LEXINGTON-FAYETTE URBAN COUNTY GOVERNMENT CONTRACT CHANGE ORDER Page 1 of 2	Date:	June 3, 2016
	Project:	Idle Hour Park Improvements
	Location:	Lexington
To (Contractor): Bluegrass Contracting Corporation 1075 Red Mile Road Lexington, KY 40504	Contract No.	242-2015
	Original Contract Amt.	\$479,230.00
	Cumulative Amount of Previous Change Orders	\$219,497.35
	Percent Change - Previous Change Orders	45.80%
	Total Contract Amount Prior to this Change Order	\$698,727.35
	Change Order No.	3

PROJECT: Idle Hour Park Improvements

CHANGE ORDER NO. 3

SUBJECT: Request Council Authorization to Execute Change Order #3 with Bluegrass Contracting Corporation in an amount **Not To Exceed** \$81,678.00 for the Idle Hour Park Improvements Project, Contract #242-2015

Figure 7: Approximate Area of Observations

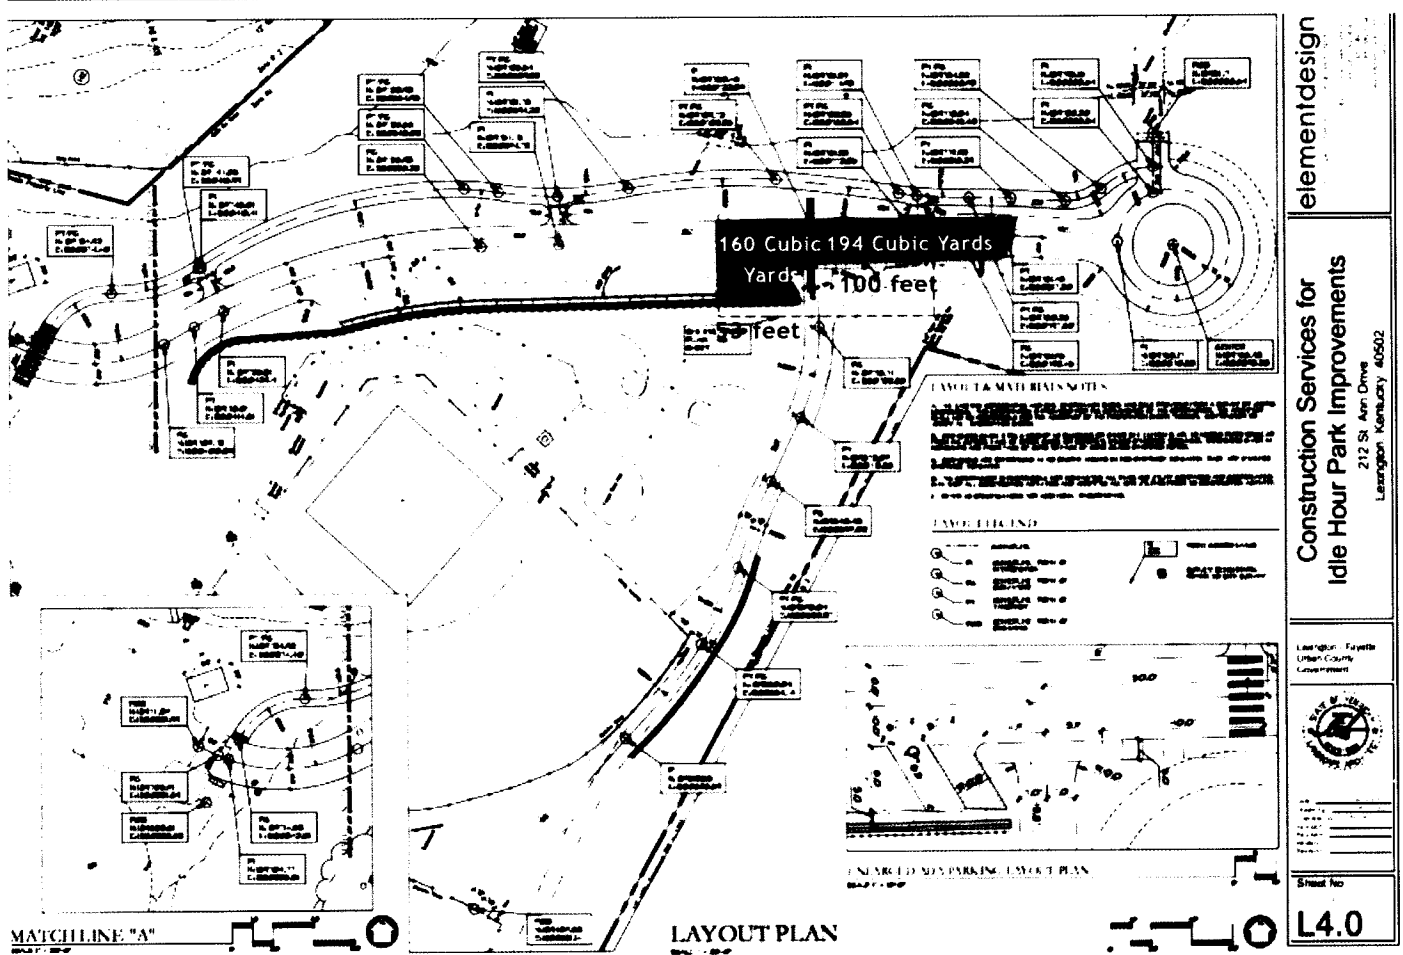
The proof roll revealed soft pumping material throughout the roadway. The pumping was evident throughout the full width of the proposed roadway. The soft pumping area measured to be 53 feet by 32 feet and 100 feet by 20 feet. We would recommend to extend the roadway undercut 5 feet beyond the roadway to maintain stability for a total of 363 cubic yards measured to be undercut and replaced.

Based on our reconnaissance of the site and our understanding of the project we believe the soft soils encountered will not support the proposed construction and will need to be stabilized to facilitate the construction above the subgrade. Such stabilization can be achieved by undercutting the soft materials down two feet, lining the soft area with a reinforced geotextile fabric and backfilling with a #2 stone like aggregate back up to the designed subgrade elevation. Once the stabilization has occurred the area should be evaluated by proof rolling to verify stability prior to placement of the pavement section.

Figure 1: Approximate Area of Observations

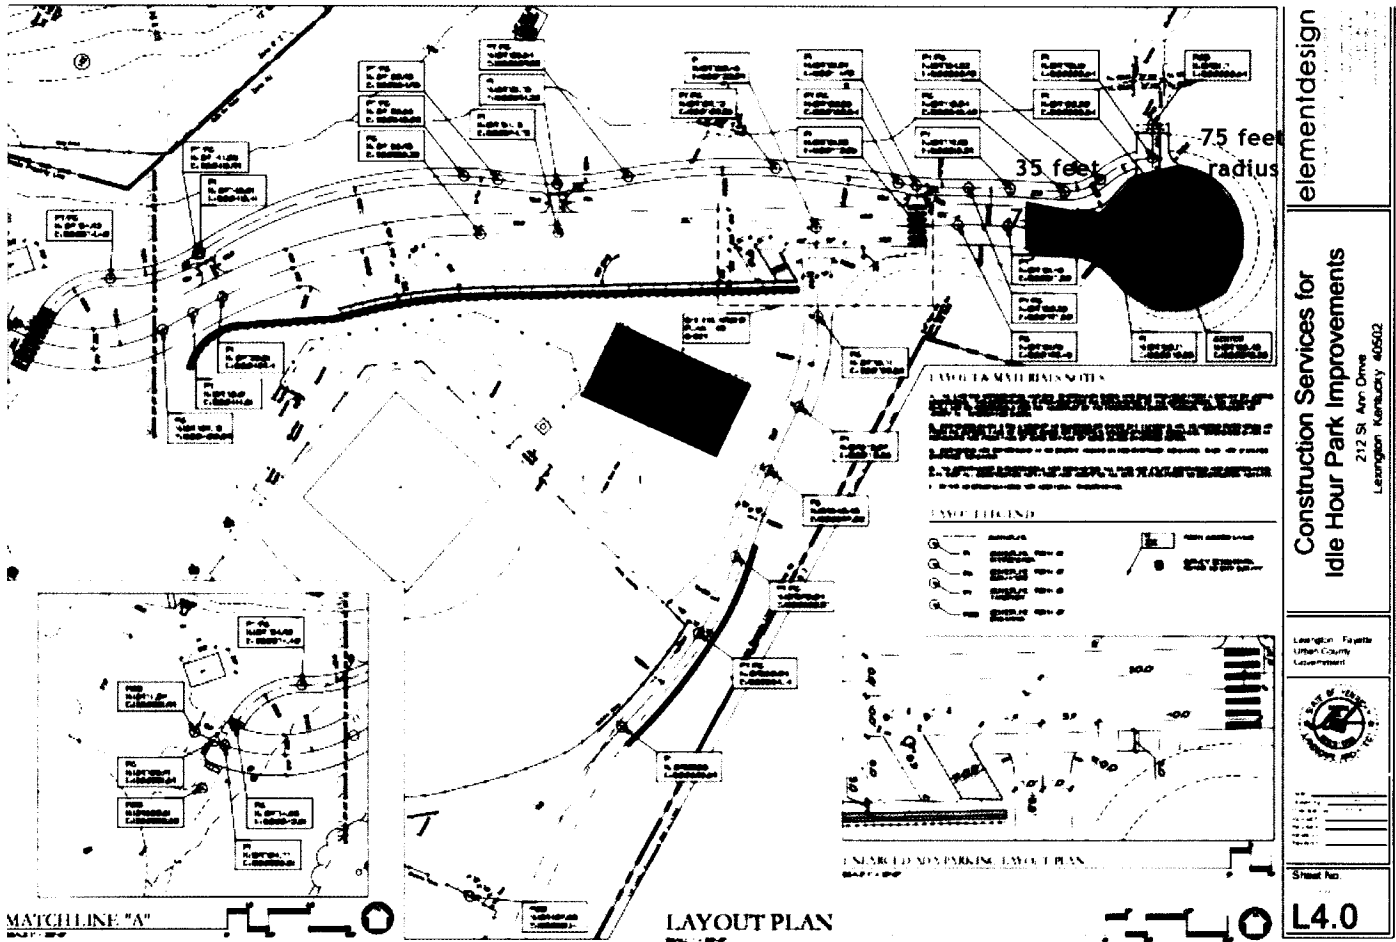
CSI observed a proof roll conducted by the contractor for the soil sub-grade approximately 35 feet of the roadway and the cul-de-sac utilizing a loaded tri-axle dump truck. The proof-roll consisted of the loaded truck routing over the sub-grade in a forward and backward motion, then moving laterally one tire width and repeating the motion until the exposed sub-grade had been rolled. The proof roll revealed soft pumping material throughout the roadway and the cul-de-sac. The pumping was evident throughout the full width of the proposed roadway. The soft pumping area measured to be 35 feet by 20 feet for the roadway and 75 feet radius of the cul-de-sac. We would recommend to extend the roadway undercut 5 feet beyond the roadway to maintain stability for a total of 450 cubic yards measured to be undercut and replaced.

Based on our reconnaissance of the site and our understanding of the project we believe the soft soils encountered will not support the proposed construction and will need to be stabilized to facilitate the construction above the subgrade. Such stabilization can be achieved by undercutting the soft materials down two feet, lining the soft area with a reinforced geotextile fabric and backfilling with a #2 stone like aggregate back up to the designed subgrade elevation. Once the stabilization has occurred the area should be evaluated by proof rolling to verify stability prior to placement of the pavement section.

Bluegrass Contracting cut the proposed basketball court to sub grade elevation. After the area had been cut, it was observed and appeared to have mixture of some clay and topsoil at this elevation.
